# PERMIT

ON-SITE SEWAGE DISPOSAL SYSTEM  
HOWARD COUNTY HEALTH DEPARTMENT  
BUREAU OF ENVIRONMENTAL HEALTH

SUBDIVISION: Triadelphia Mill Road Property LOT NUMBER: 3

ADDRESS: 14265 Triadelphia Mill Rd PROPERTY OWNER: Donald Holliday Jr.

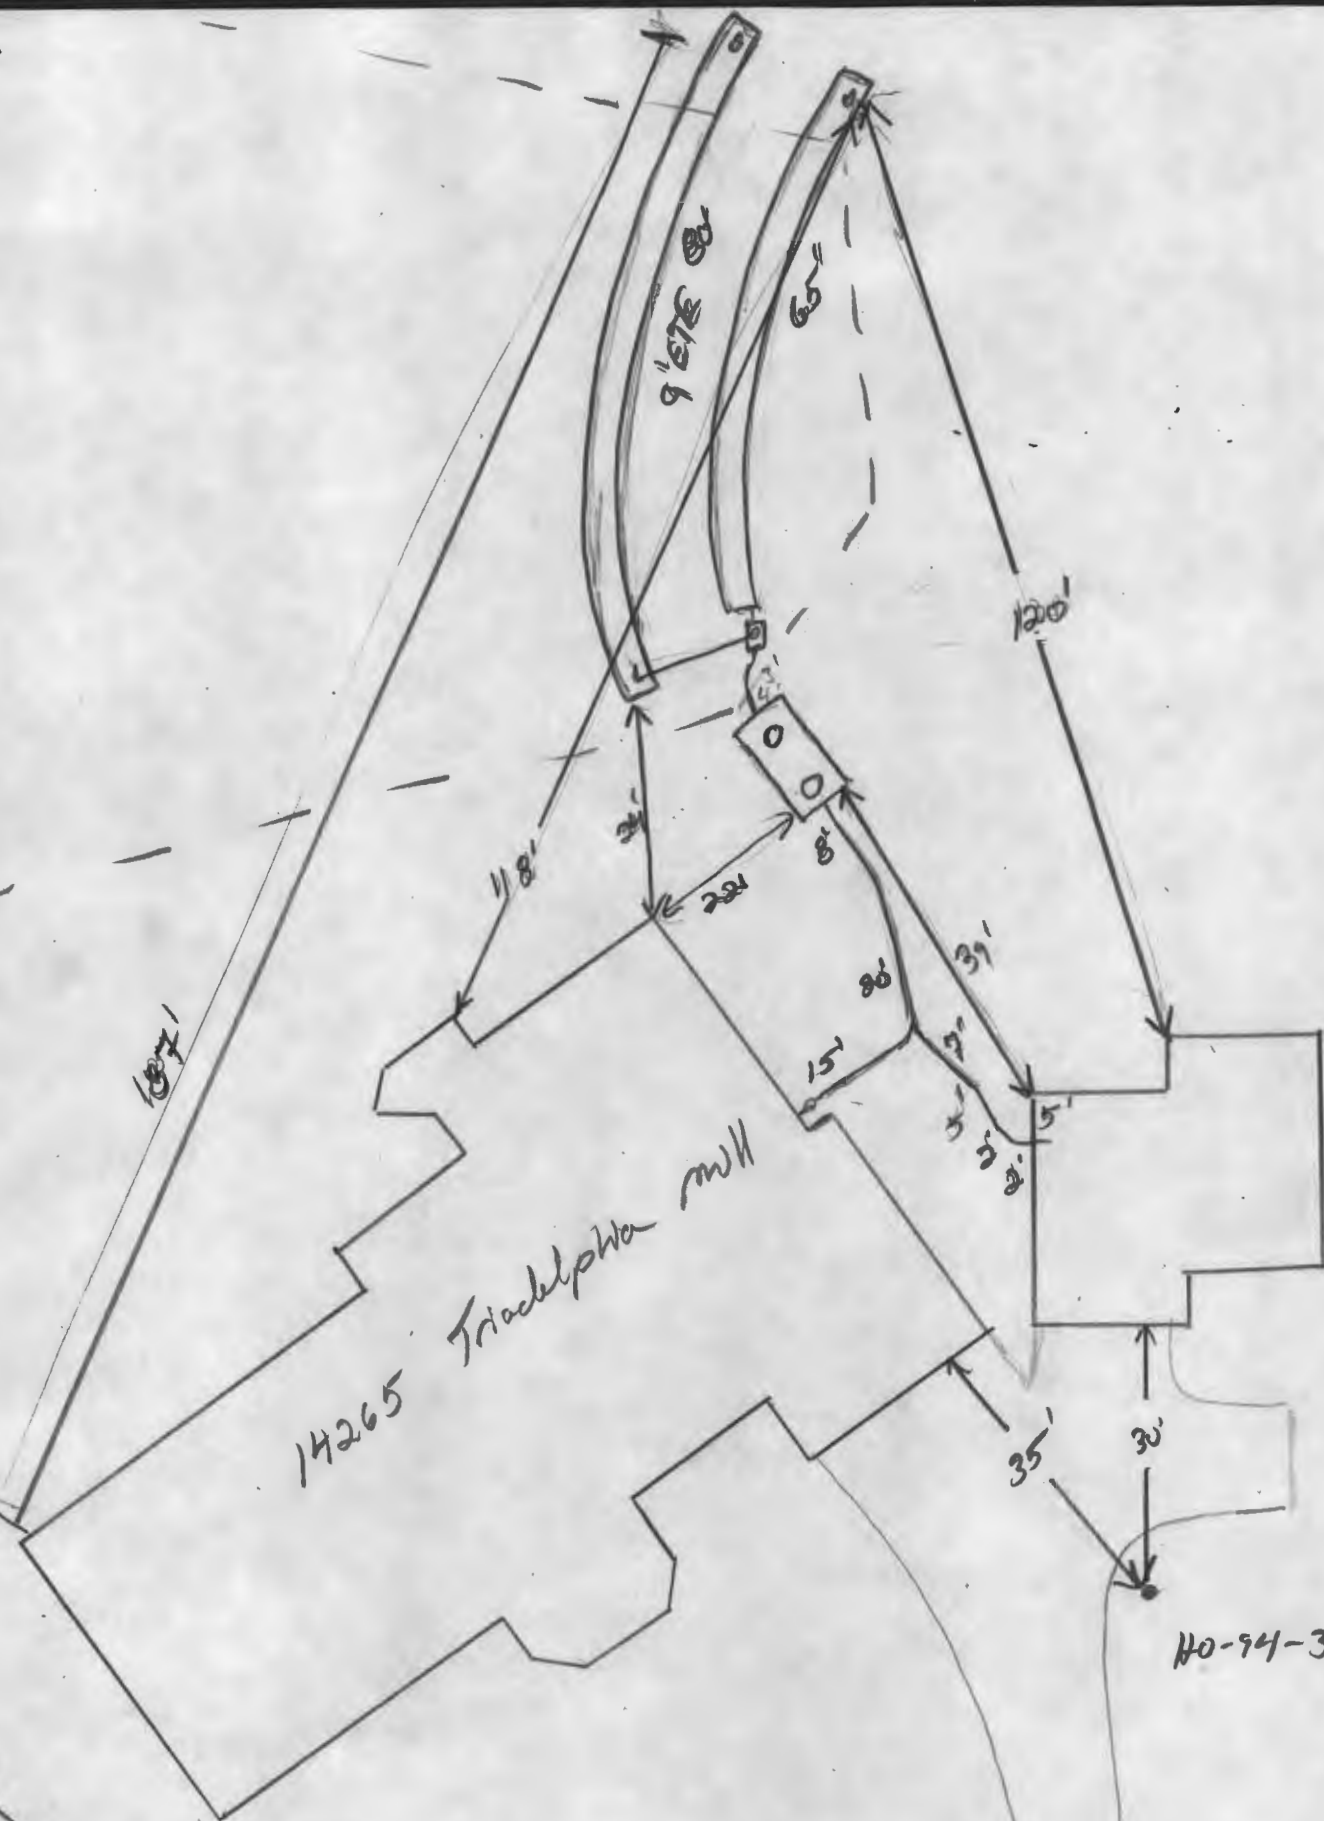
8/21/08 Contractor to install @ a 65 inch 72' trench on contour. Keep tanks 20' from dwelling

9/12/08 Tank set. Plumbing installed from house to tanks.  
INSTALLATION: Contractor had installed plumbing from "Guest house" into line to tanks. Was not aware of the DM runs. (KW)

9/16/08 Contractor has finished up trenches. Approx. 44" on the width. They used the wrong type of filter cloth and will have to change and keep uncovered. (KW) 9/17/08 Correct filter fabric used. Dbox had to be adjusted to make fall to first trench. looks good. OK to backfill. (KW)
